Origination Form

Proposed Revisions to a Standard Plans Index

Originator:	Stepp, Richard	Index Number:	536-002
Date:	7/25/2024	Sheet Number(s):	1, 27, 28
E-mail:	richard.stepp@dot.state.fl.us	Index Title:	Guardrail Transitions and Connections for Existing Bridges

GUARDRAIL APPROACH TRANSITION CONNECTIONS FOR EXISTING FLAT SLAB, PRESTRESSED BEAM AND GIRDER BRIDGES WITH SAFETY SHAPE TRAFFIC RAILING EXTENDING LESS THAN FULL APPROACH SLAB LENGTH

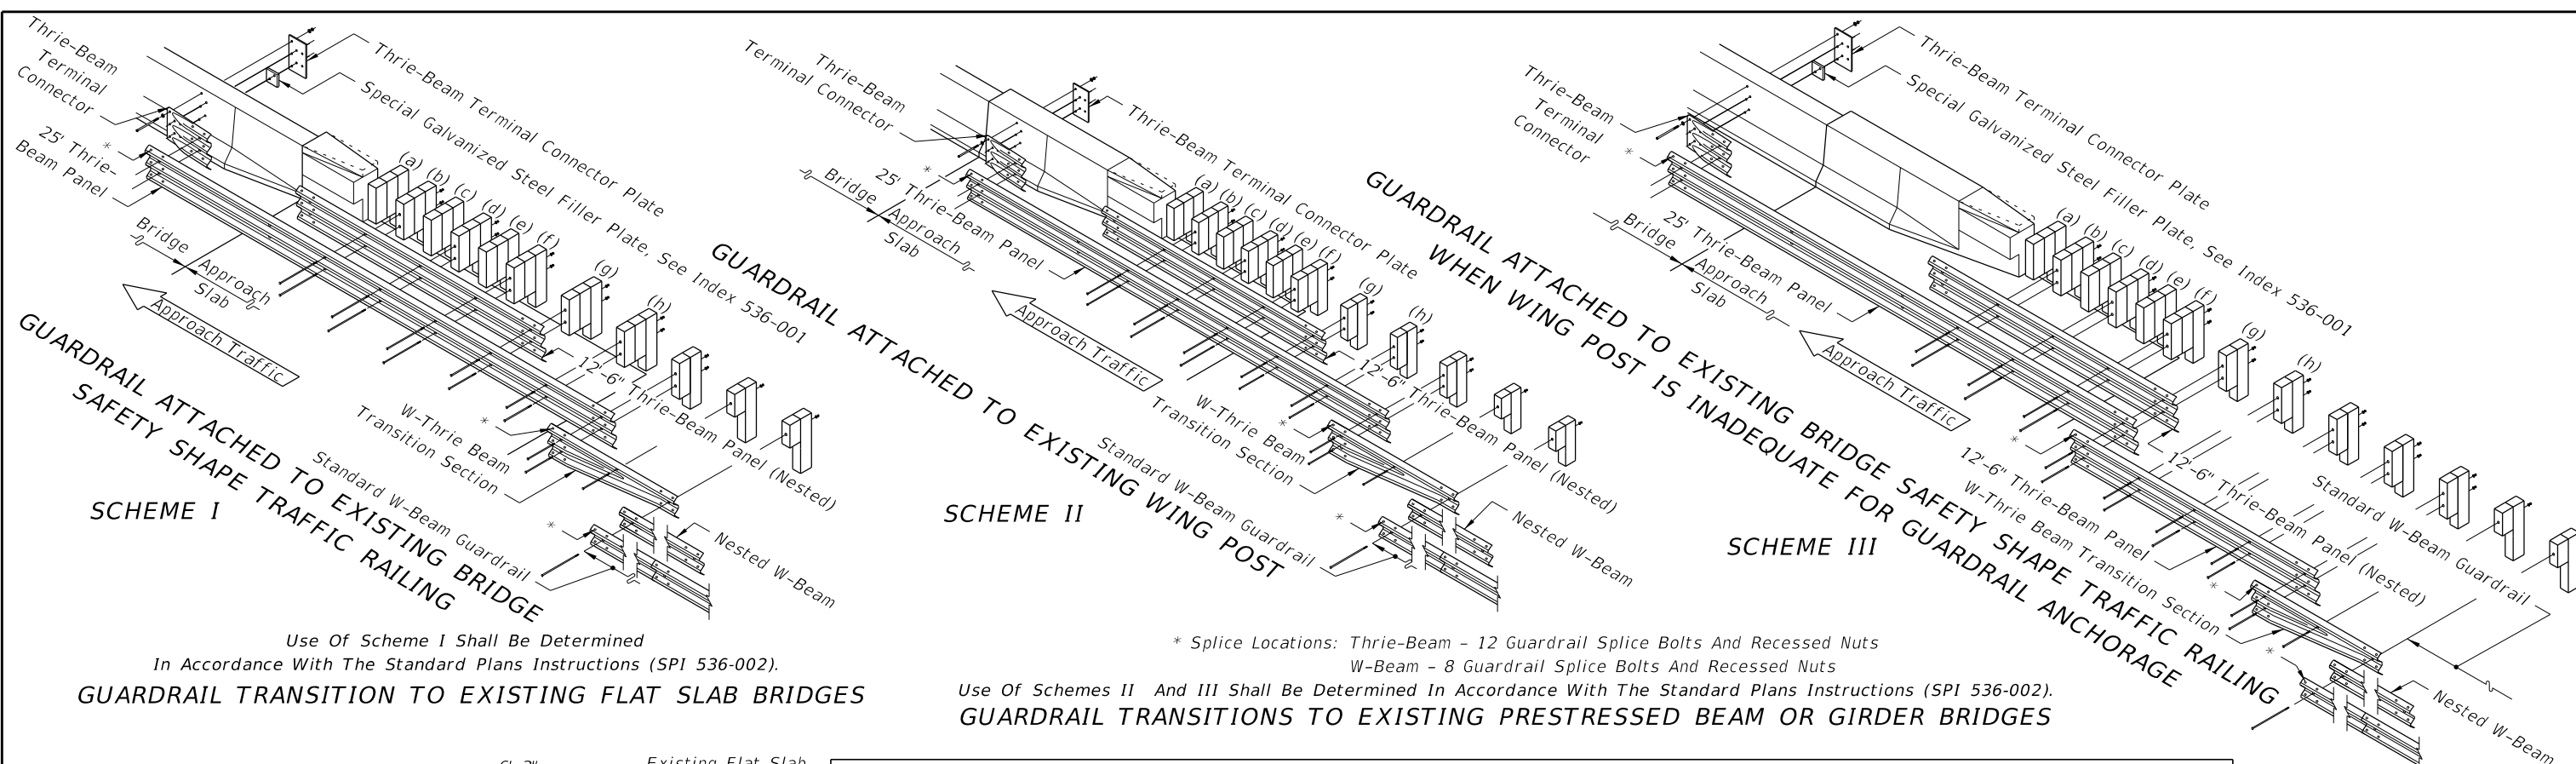
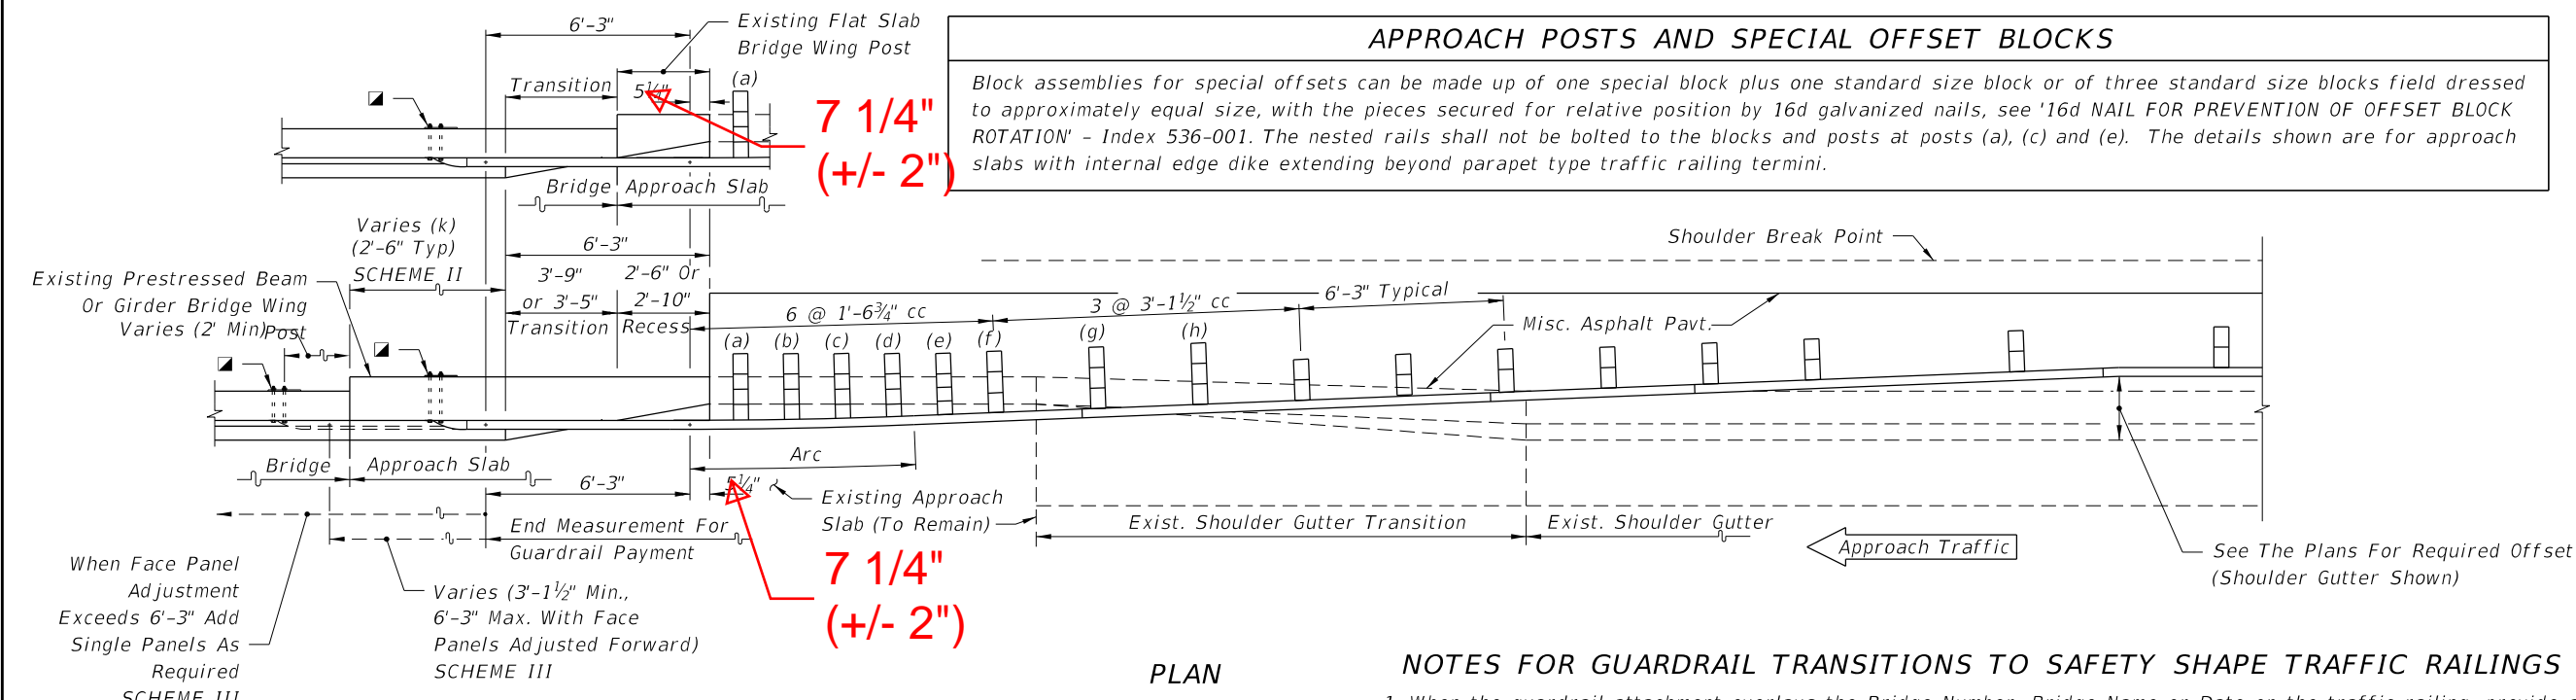
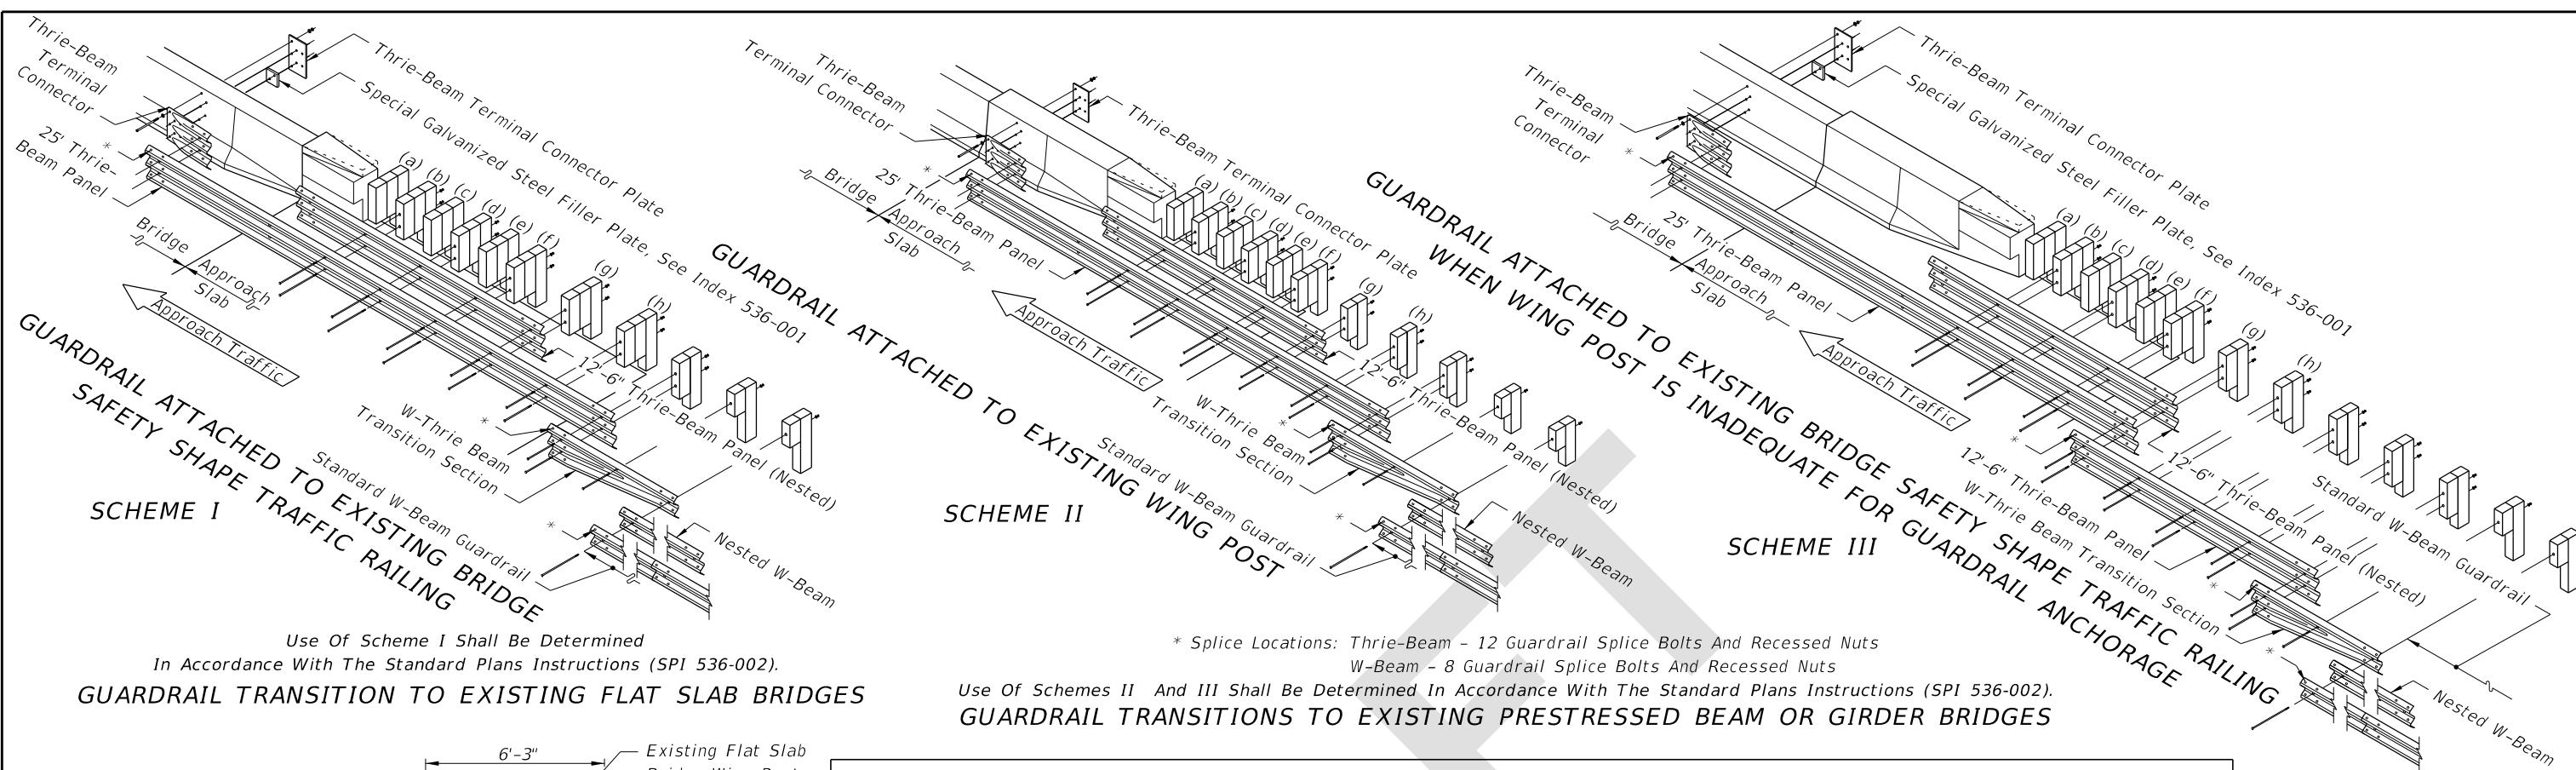
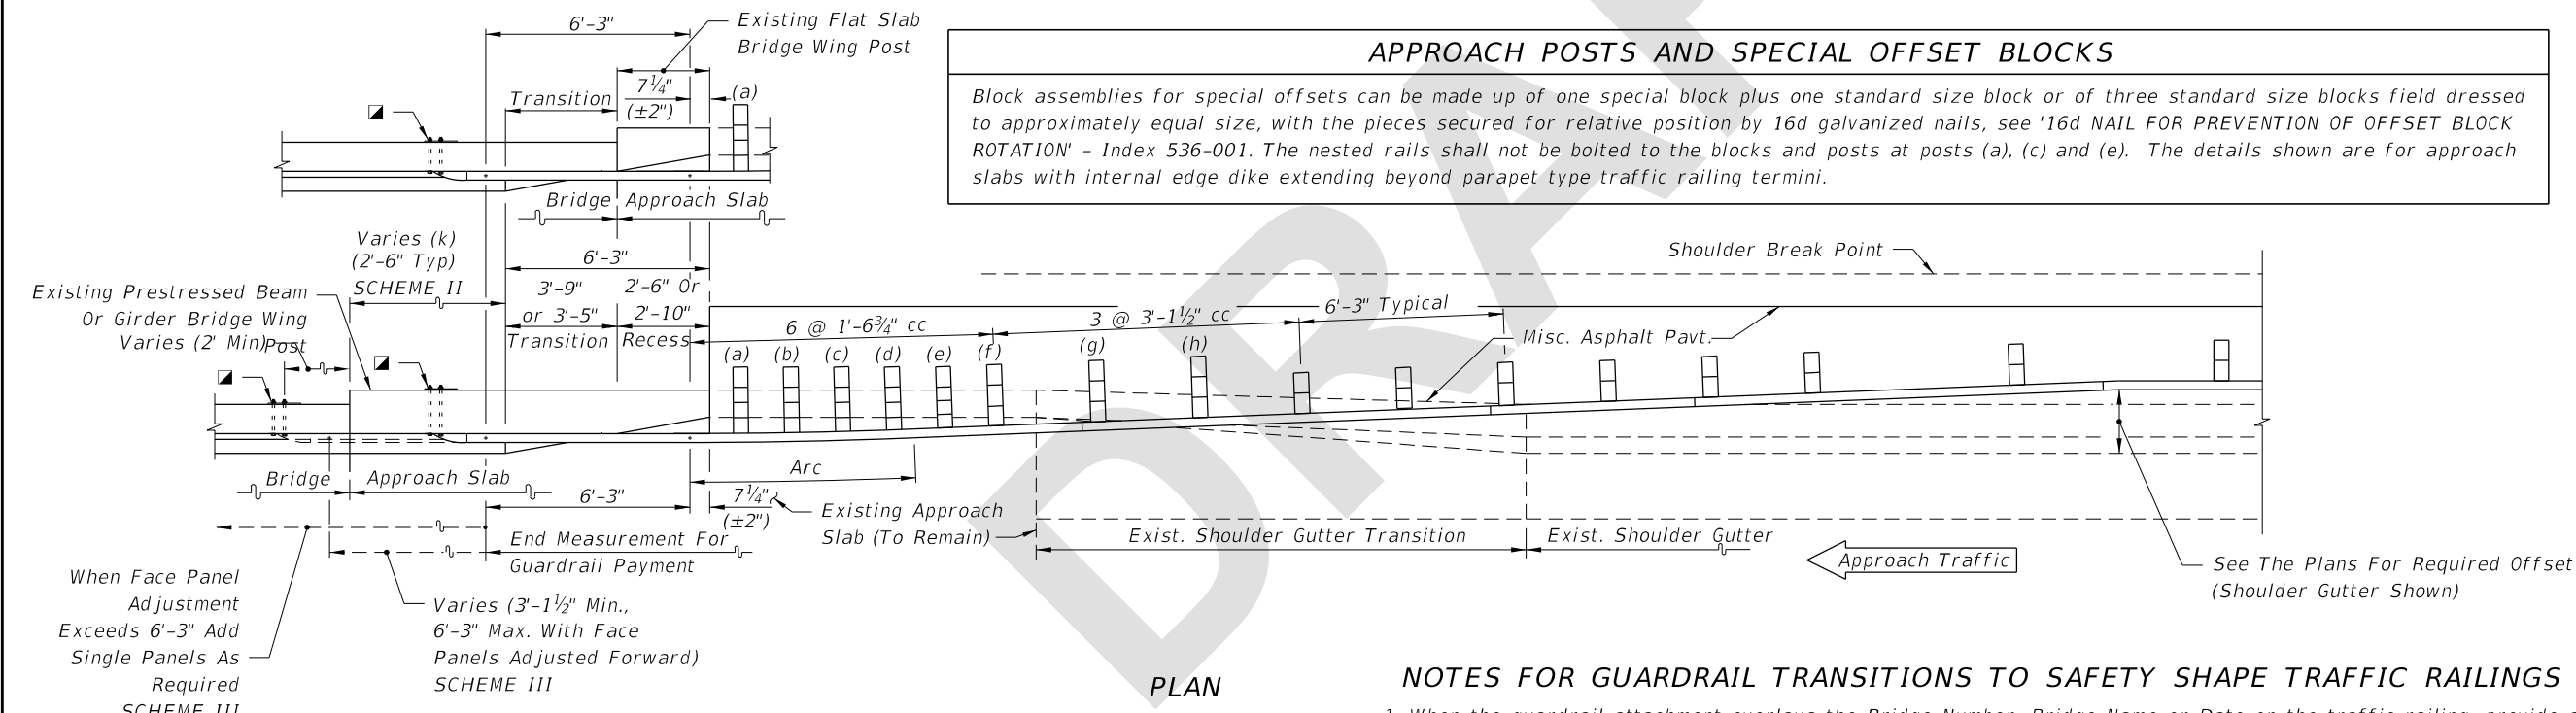
Sheet 1: Added a note explaining required rectangular washer usage to General Note 2.
 Sheet 27: Changed guardrail's longitudinal alignment measurement from the end of concrete from 5 1/4" to 7 1/4" (+/- 2")
 Sheet 28: Changed guardrail's longitudinal alignment measurement from the end of concrete from 5 1/4" to 7 1/4" (+/- 2")

Sheet 1: Contractors questioned if the rectangular washer policy of the referenced Index 536-001 applies, so this added note provides that clarification.
 Sheets 27 & 28: Changed longitudinal dimension to align with crash-tested systems and provide a broader tolerance for placement that follows successful practices in other states.
